REGULATORY INFORMATION DISTRIBUTION SYSTEM (RIDS)
DISTRIBUTION FOR INCOMING MATERIAL

RESPONSE TO NRC LTR DTD 04/07/78... FORWARDING ANSWERS TO THE CYCLE 4 RELOAD
QUESTIONS AND ADDL CONCERNS AS REQUESTED BY NRC.

PLANT NAME: THREE MILE ISLAND - UNIT 1

Three Mile Island Nuclear Station, Unit 1 (TMI-1)
Operating License No. DPR-50
Docket No. 50-289

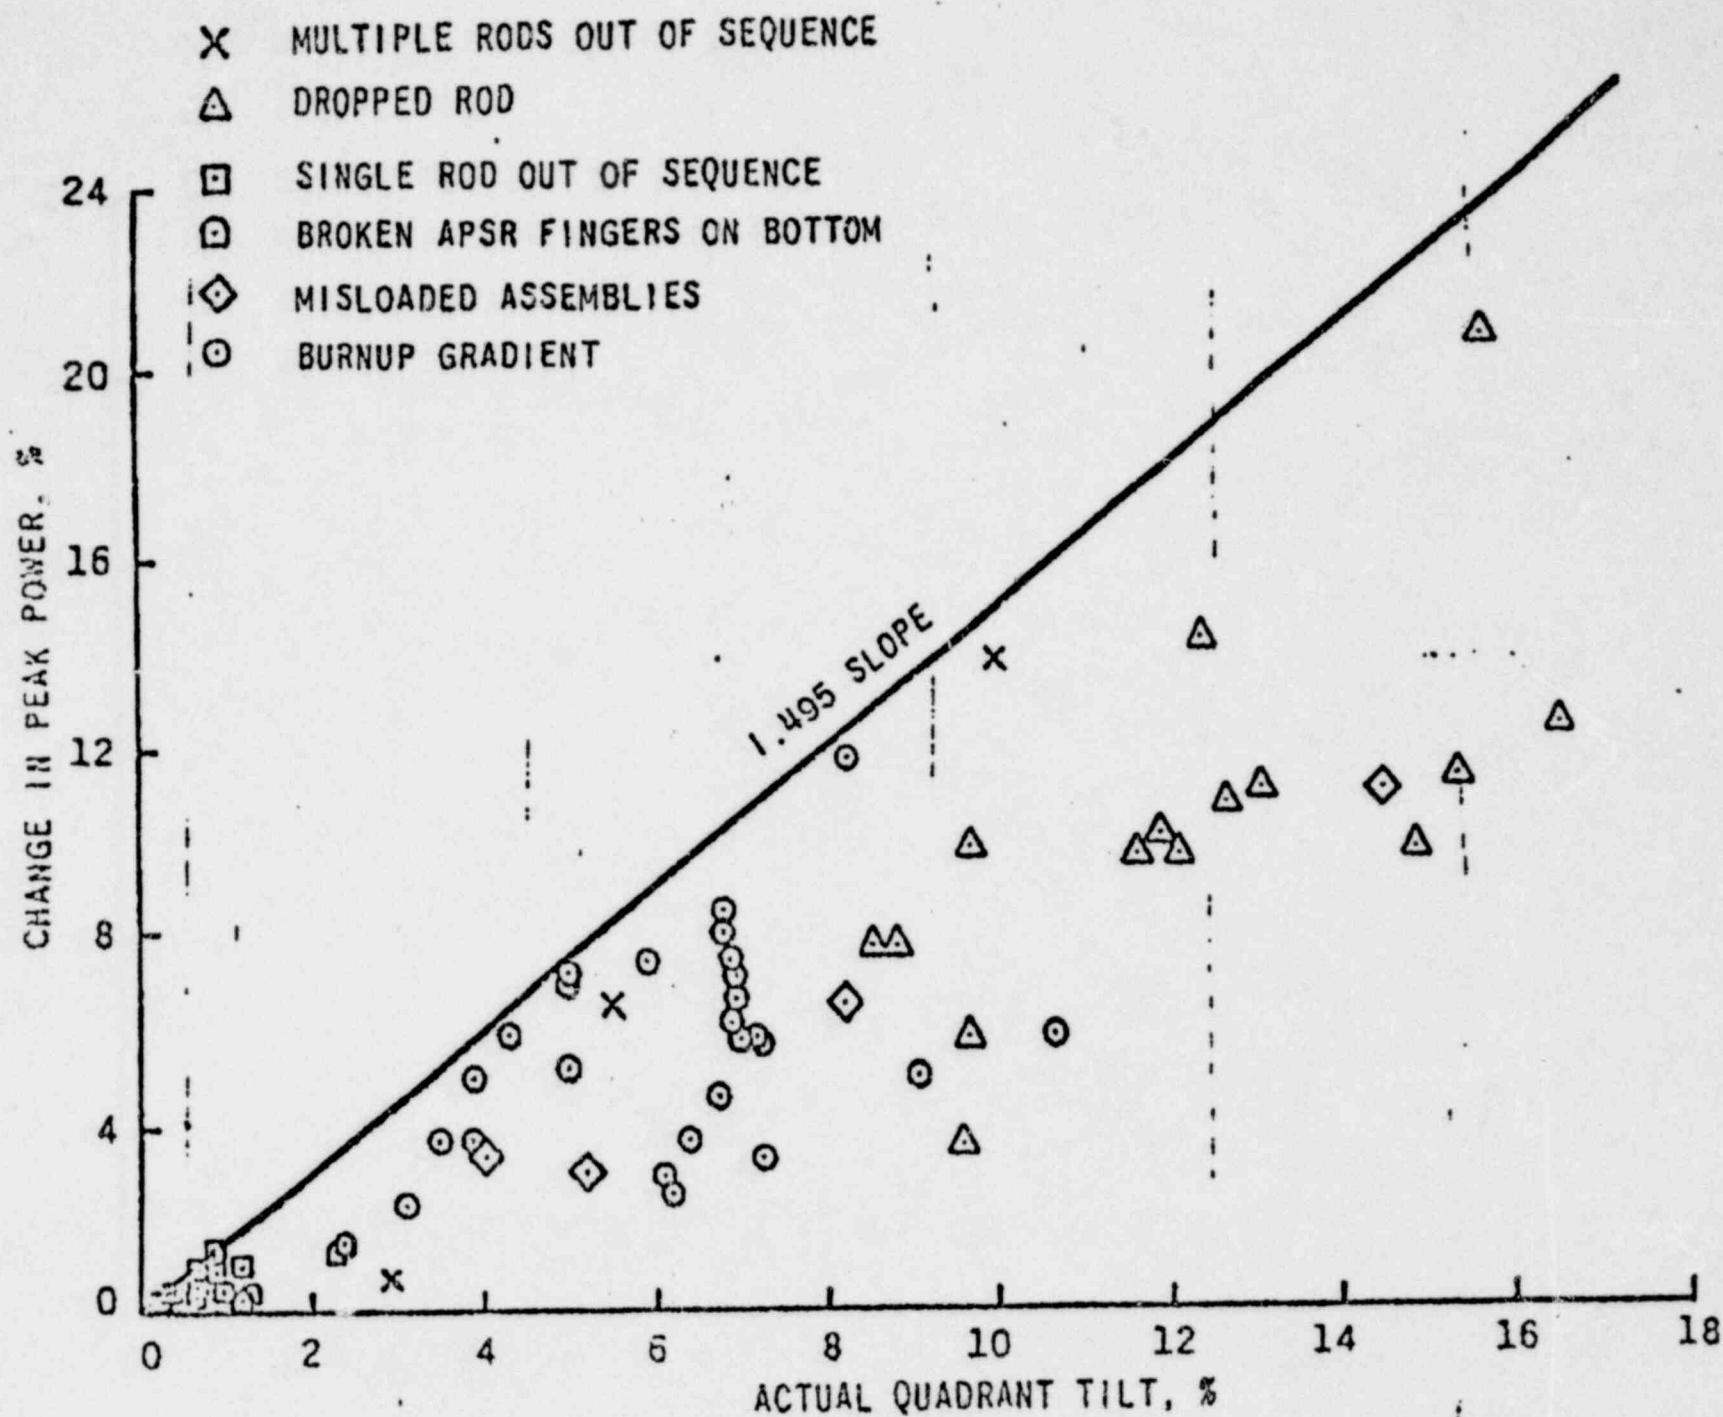
Provide an explanation of the increase in quadrant tilt from 3.41 to 4.92% being proposed in the Technical Specifications. What kind of a penalty is taken in the calculation of peaking factors in order to account for the allowable 4.92% tilt? Provide the basis for the adequacy of this penalty.

The data on calculated power peak increase due to quadrant power tilt are presented in the attached figure. These data are from both Figure 3-5 of BAW-10078 and recent investigations of the Oconee I, Cycle 4 tilt behavior. The following discussion characterizes the method of tilt inducement used in the various calculations.

Following the legend in the attached figure, the first tilt type considered was that due to multiple rods out of sequence (symbol x). Two of these values are from Figure 3-5 of BAW-10078, and one from recent 3-D FLAME investigations of potential Oconee I multiple misaligned rods. These three represent from 2-6 rods misaligned. In the Oconee I case, rods in diagonally opposite quadrants were moved in opposite directions. The core was modeled with 24 axial nodes of 6" each. Bank 7 was misaligned such that one rod (on a minor axis) was one node above the bank average and the diagonally opposite rod was one node below the bank average.

The next type of tilt, shown with the symbol Δ , was that caused by a dropped rod. In addition to the four cases from Figure 3-5 of BAW-10078, eleven additional cases were calculated for the Oconee I, Cycle 4. Every potential dropped rod location, including those on the major axes, was investigated.

The third tilt type was that caused by a single rod out of sequence (symbol \square). These ten cases were as reported in BAW-10078. The results are all clustered at low tilt and peak increase values. These were 3-D PDQ07 cases.

The fourth tilt type shown (symbol \ominus) was that due to various numbers of individual APSR fingers (1-3) assumed to be broken off and resting on the bottom in three different assembly locations. Three-dimensional FLAME calculations for the beginning of Oconee I, Cycle 4 were run at 40% FP, and without xenon, to amplify peaking effects.

The fifth tilt type was generated assuming several (3-6) misloaded assemblies (symbol \diamond). Enrichment deviations of from $\pm .01$ w/o (6 locations) to $-.90$ w/o (3 locations) were investigated. Again, the beginning of Cycle 4 of Oconee I was the configuration analyzed.

The sixth and final tilt type investigated (symbol Θ) was that caused by a non-symmetric burnup distribution in two fuel batches being carried over into Cycle 4 of Oconee I. Partial results of these calculations are given in BAW-1477. FLAME was used to simulate an end of Cycle 3 burnup asymmetry of +2% in one core quadrant and -2% in the diagonally opposite quadrant. The fuel was then shuffled into the Cycle 4 pattern and depleted in full core geometry to 50 EFPD. The power level was set at 40% FP to 4 EFPD, at 75% FP from 4 to 23 EFPD, and a 100% FP from 23 to 50 EFPD. A total of 26 variations of power level and burnup supplied data for the points plotted.

As can be observed from the figure, all of the over 60 data points fall below the line which has a slope of 1.495. This was the value assumed in assigning a 7.36% peak increase to an allowable tilt of 4.92% for the TMI-1, Cycle 4 Technical Specification.
